RS-02-196

LaSalle County Station, Units 1 and 2  
Facility Operating License Nos. NPF-11 and NPF-18  
NRC Docket Nos. 50-373 and 50-374

**Subject:** Revised Request for Amendment to Technical Specifications  
Justification for the Continued Use of Technical Specifications, Section  
3.4.11, "RCS Pressure and Temperature (P/T) Limits"

Figure 3.4.11-5 (Page 1 of 1)

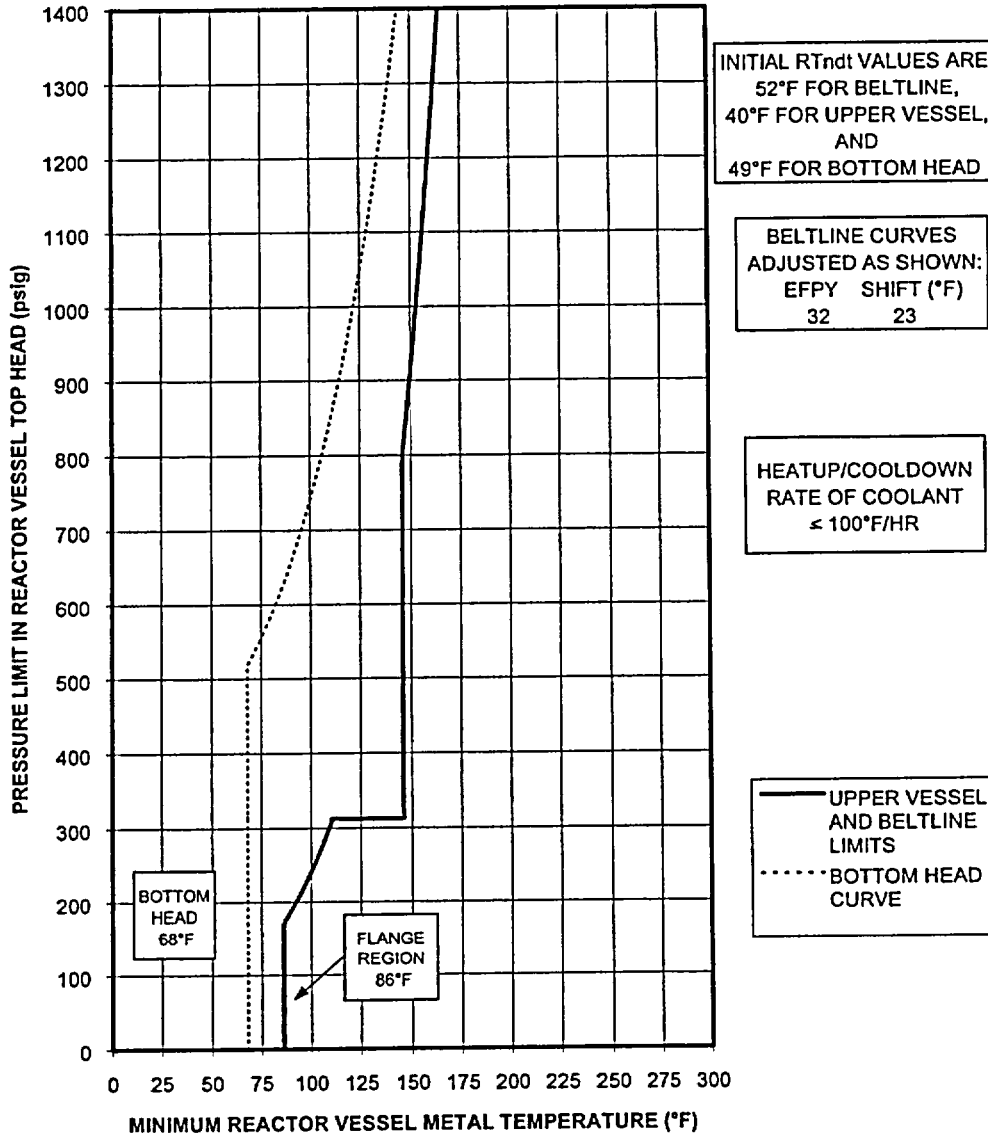
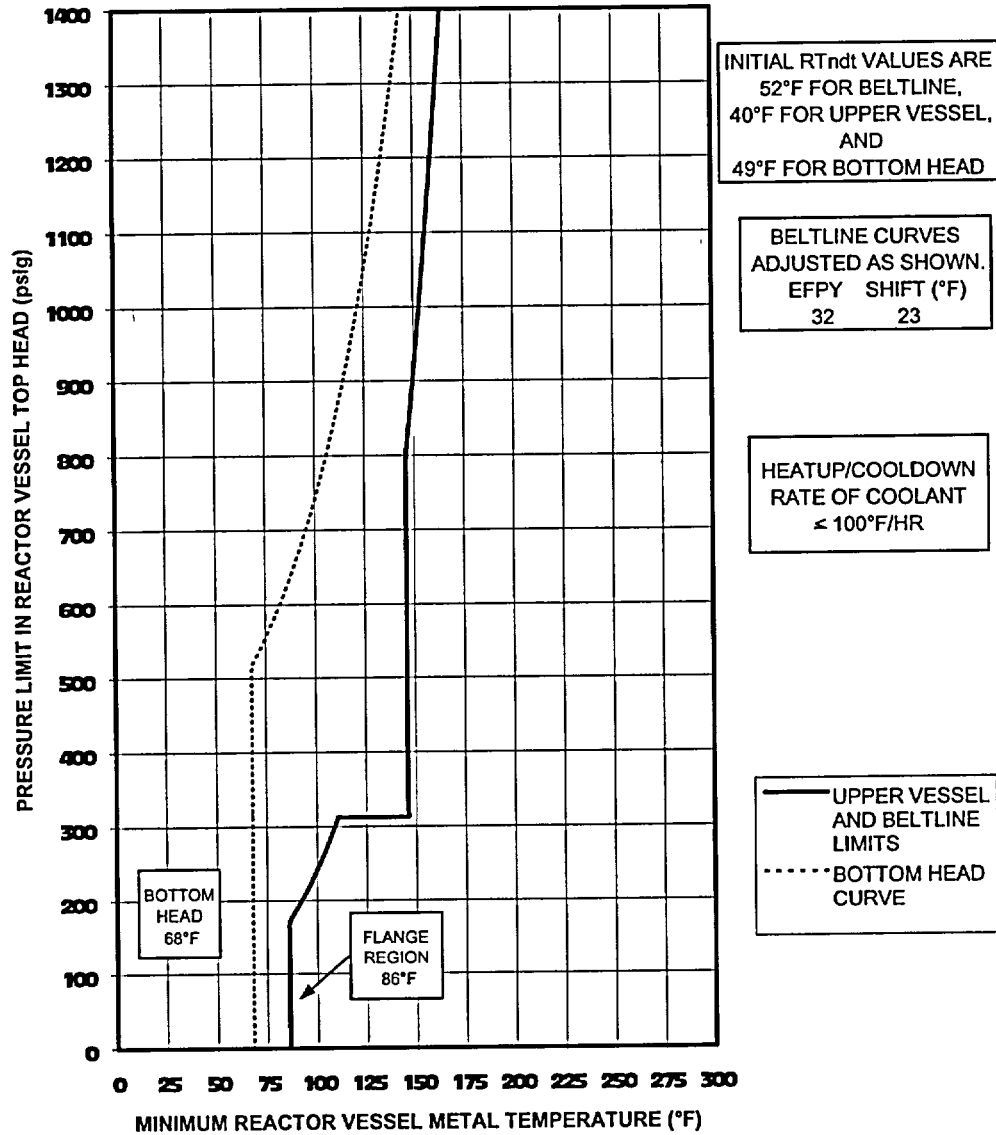
UNTIL DECEMBER 15, 2004

Unit 2  
Minimum Reactor Vessel Metal Temperature vs.  
Reactor Vessel Pressure (Valid up to 32 EFPY)

Unit 2  
Minimum Reactor Vessel Metal Temperature vs.  
Reactor Vessel Pressure (Valid until December 15, 2004)

Figure 3.4.11-6 (Page 1 of 1)

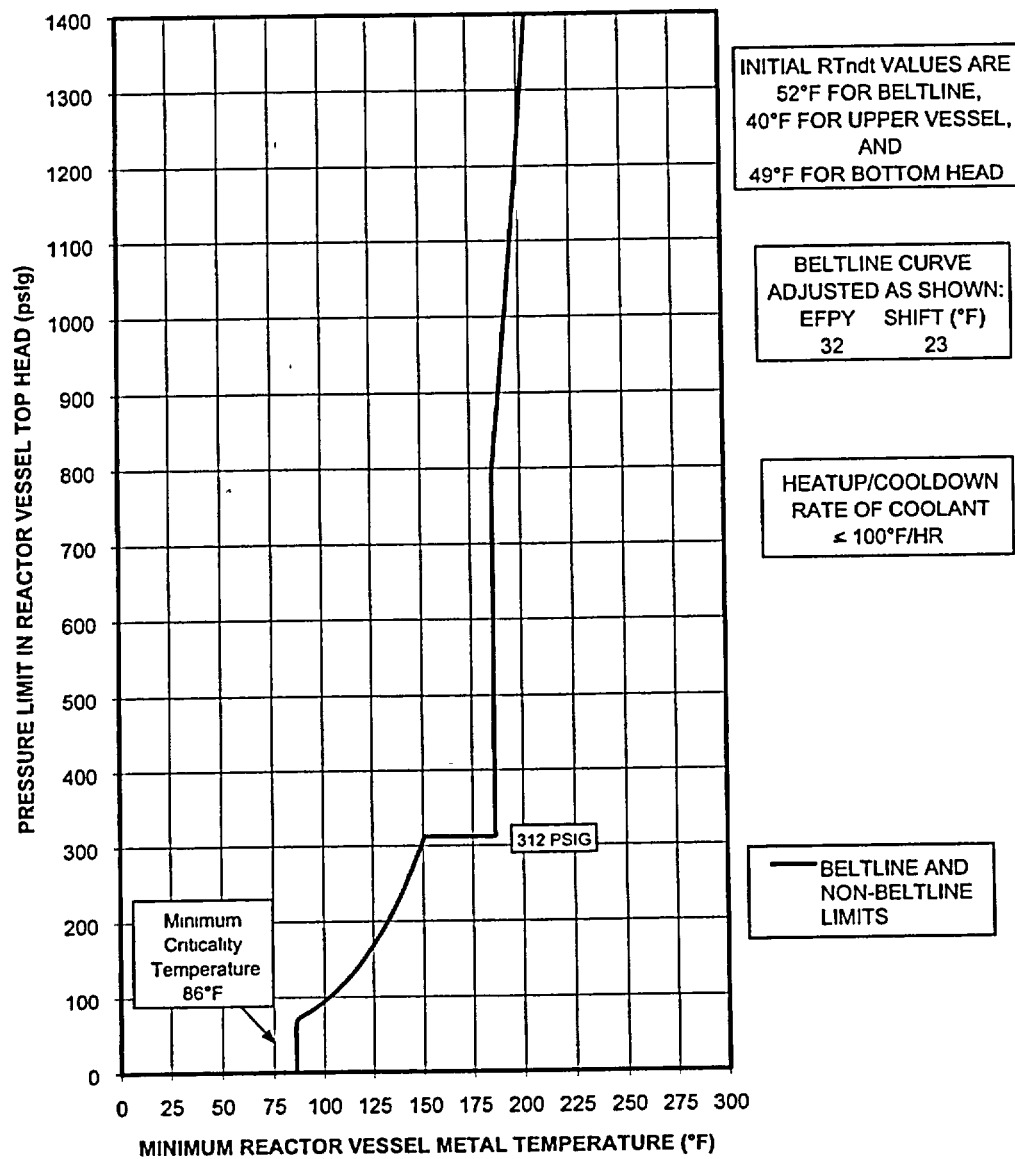
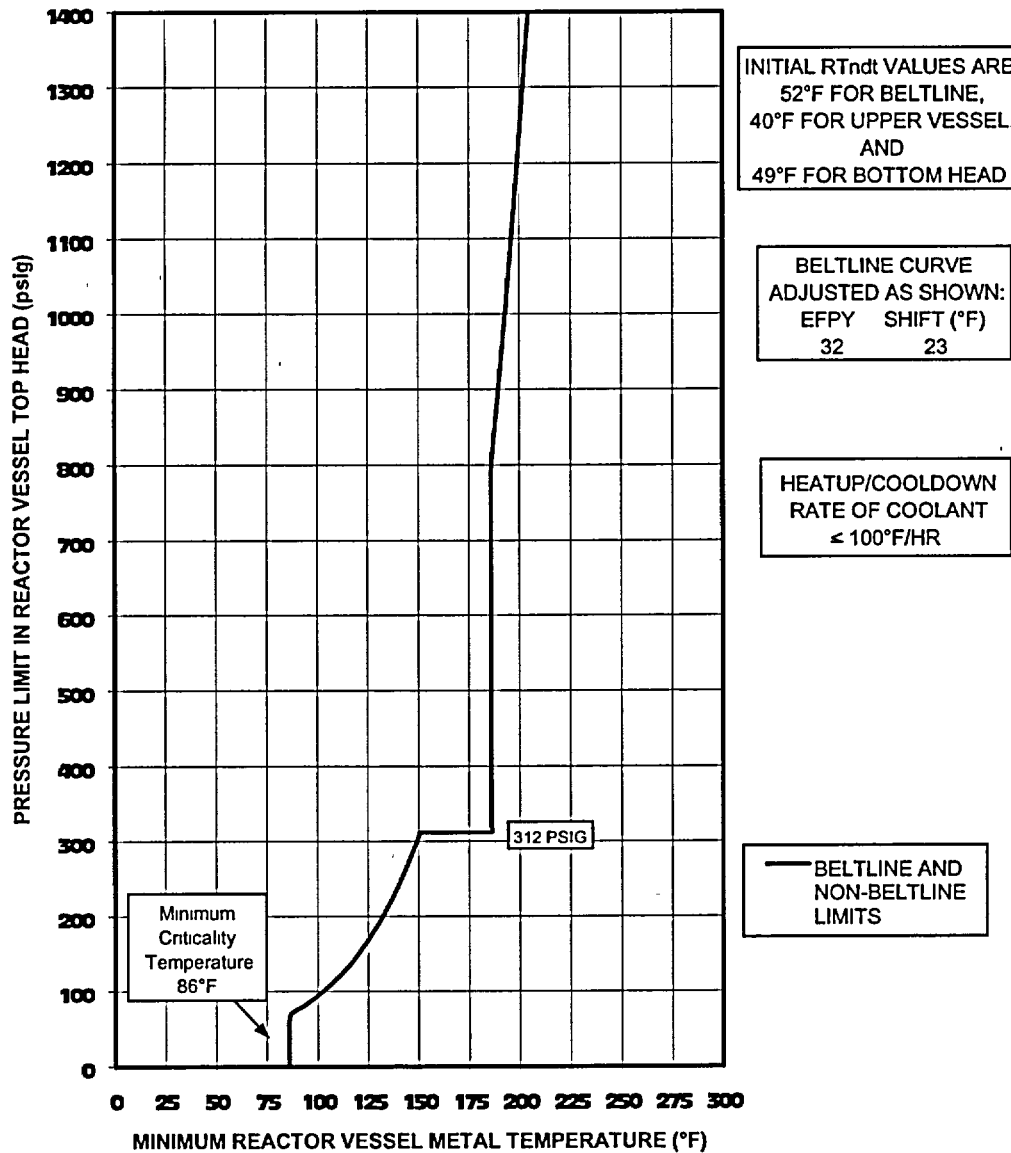
UNTIL DECEMBER 15, 2004

Unit 2  
Minimum Reactor Vessel Metal Temperature vs.  
Reactor Vessel Pressure (Valid up to 32 EFPY)  
*UNTIL DECEMBER 15, 2004*

Unit 2  
Minimum Reactor Vessel Metal Temperature vs.  
Reactor Vessel Pressure (Valid until December 15, 2004)
